## **Response to request for review**

### **“SeAH Besteel fuel switching project”(Ref. no. 2735)**

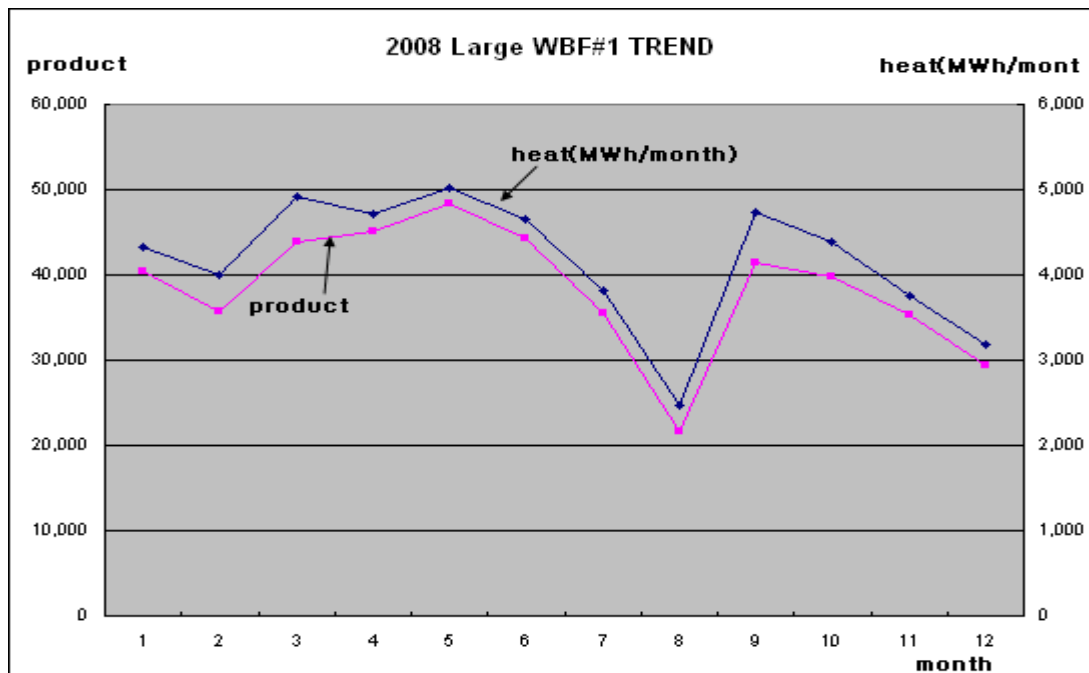
The PP/DOE are requested to clarify how the baseline emissions calculations comply with the methodology which defines the project output in terms of energy.

The PP/DOE are requested to clarify how the monitoring plan complies with the methodology which defines the project output in terms of energy.

By the way, to use output product is easier than output heat for calculating baseline and monitoring in this case. So, PP investigated that it would be possible to use output product in this methodology. At first, PP compared the trends of output product and output heat. The trends are very similar to each other. (Refer to Annex. 3 of PDD). Next, PP carried out regression analysis and got 0.984 as coefficient of correlation, 0.969 as coefficient of determination (confidence interval 95%).

The validation team checked below correlation analysis figure and data of product output and Heat output provided by PP.

There is interrelationship between product output and heat output. Thus, both product output and heat output may be applied as project output. However, heat output can be calculated with three factors as shown in the equation above and thus, uncertainty may be higher than product output. For this reason, PP had applied heat output as project output. The validation team also concluded that product output is appropriate as parameter substituting net energy output as product output can be considered as indirect energy output.
